City of Plymouth Planning Commission

Regular Meeting Agenda

**Special Land Use and
Site Plan Review
For
Plymouth, Michigan**

Applicant:	Bryan Bender Fortisnet Lease 30445 Northwestern Highway Farmington Hills, MI 48334
Project Name:	Scooter's Coffee Drive-Thru
Plan Date:	September 17, 2021
Location:	1490 W. Ann Arbor Road
Zoning:	ARC – Ann Arbor Road Corridor District
Action Requested:	Special Land Use and Site Plan Approval
Required Information:	Any deficiencies are noted in the report.

2 EXTERIOR ELEVATIONS
SCALE: 1/4" = 1'-0"

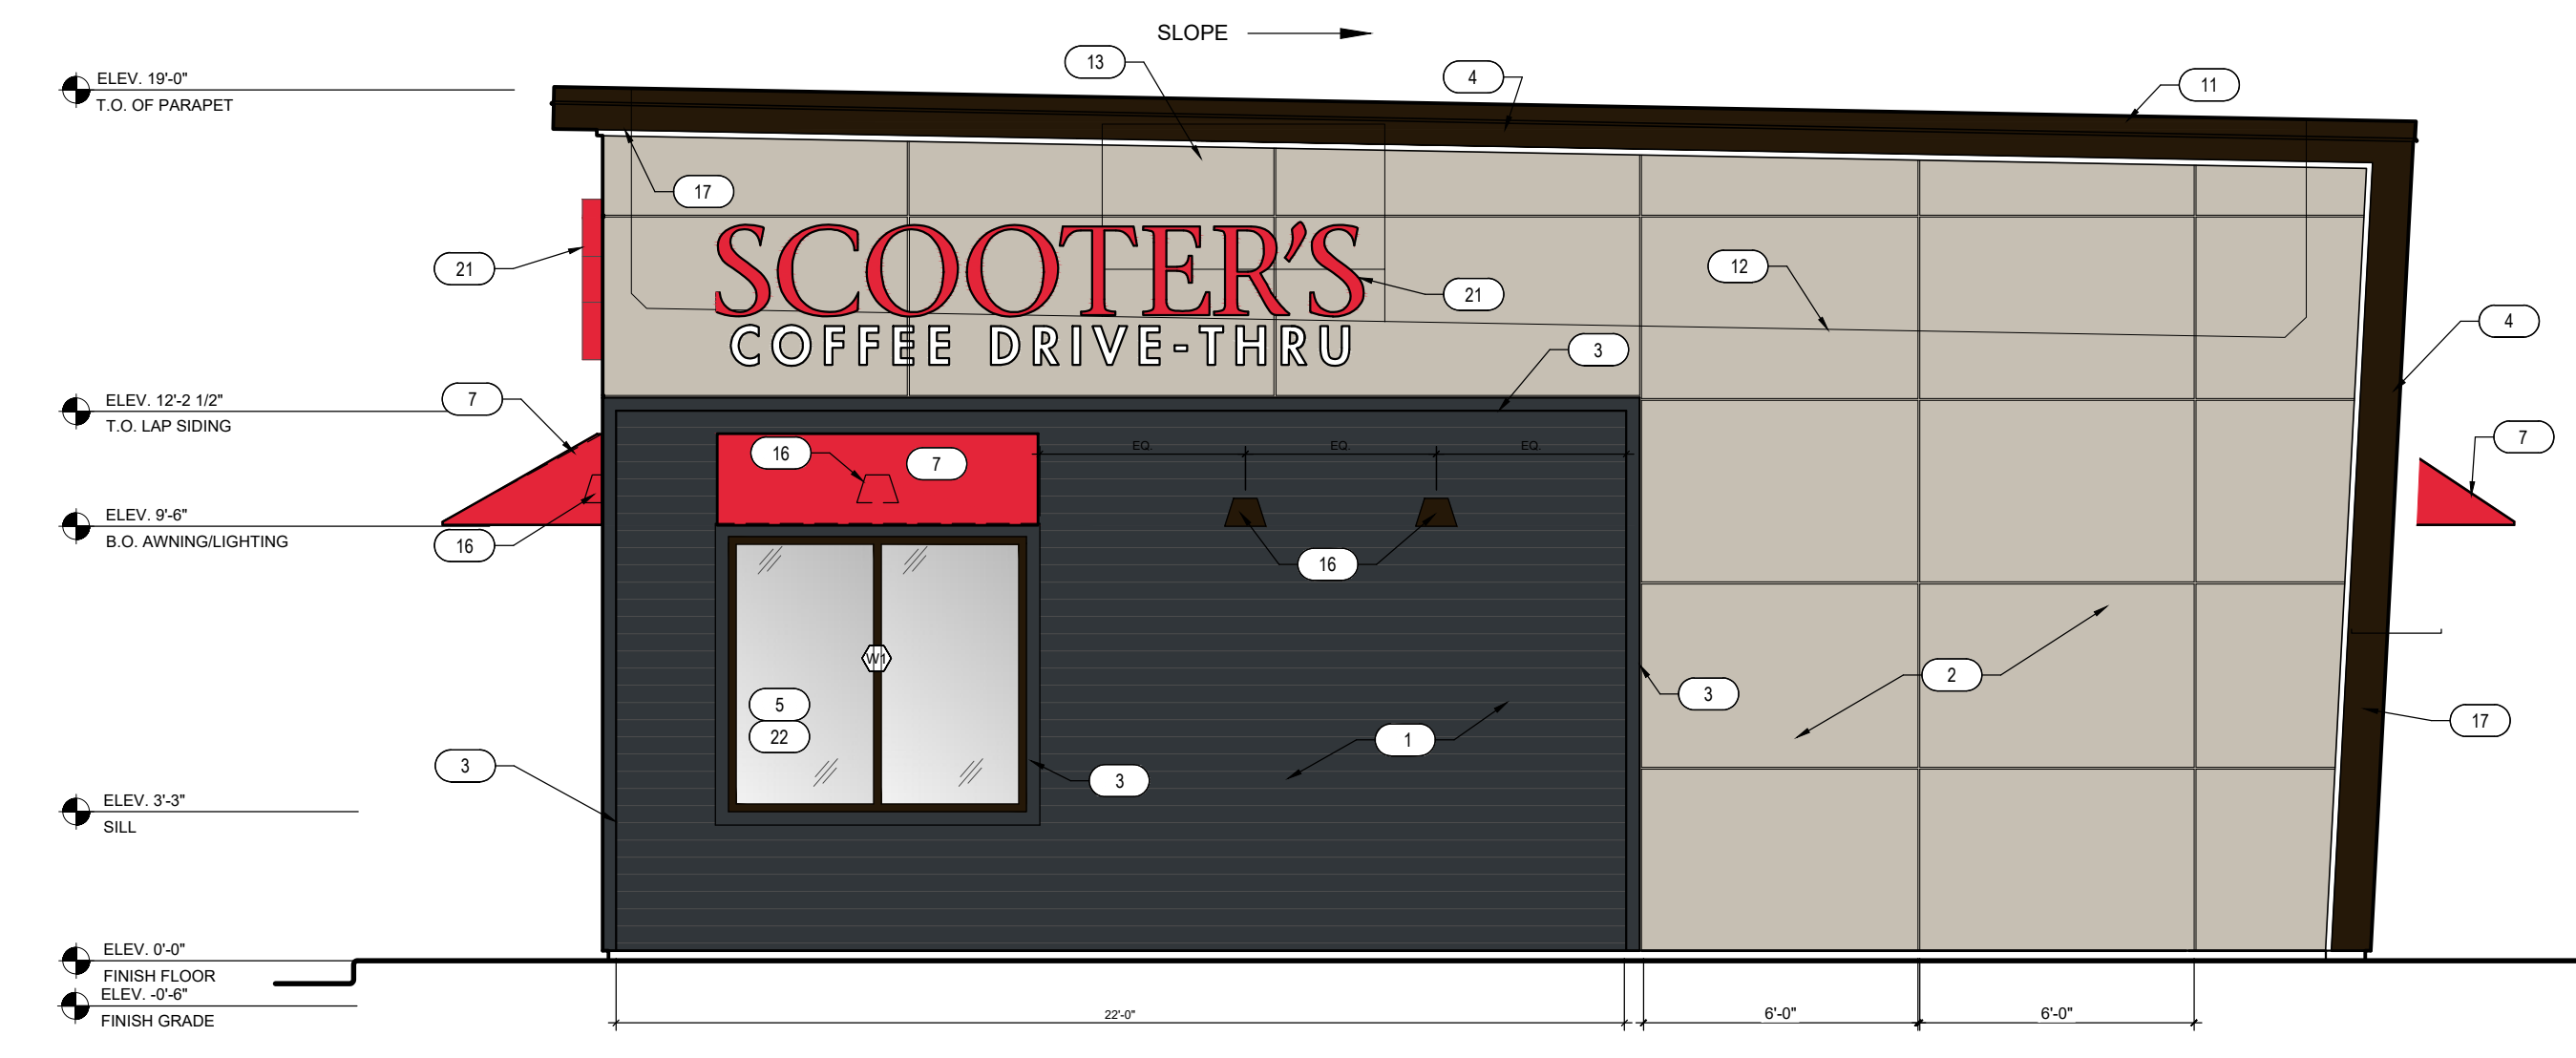
The building elevations show a corporate building design that is intended to brand this site and tie it specifically to this particular business. The ARC District has guidelines for building design specified in Section 78-161(d)(1)(f). It calls for the use of brick, stone, black wrought iron accents, peaked roof elements, building architectural detail to enhance door and window openings, and other elements approved by the Planning Commission. It also calls for a façade adjacent to property zoned or used as residential to be designed, treated, and finished in a uniform manner consistent with the exterior of the front of the building. We suggest that the Planning Commission and applicant discuss the option of a building design that is more universal, as well as the proposed north facade. See the photo below as an example that has some of the elements called for in the ARC District guidelines:

- a. The possibility of a more universal building design that better fits in with the existing character along the Ann Arbor Road Corridor, and whether the north façade has the same treatment as the front façade, as required.
- b. Planning Commission determination of a masonry screen wall (vs. wood fence) between the site and residential neighbors.
- c. Pedestrian service via a walk-up window.
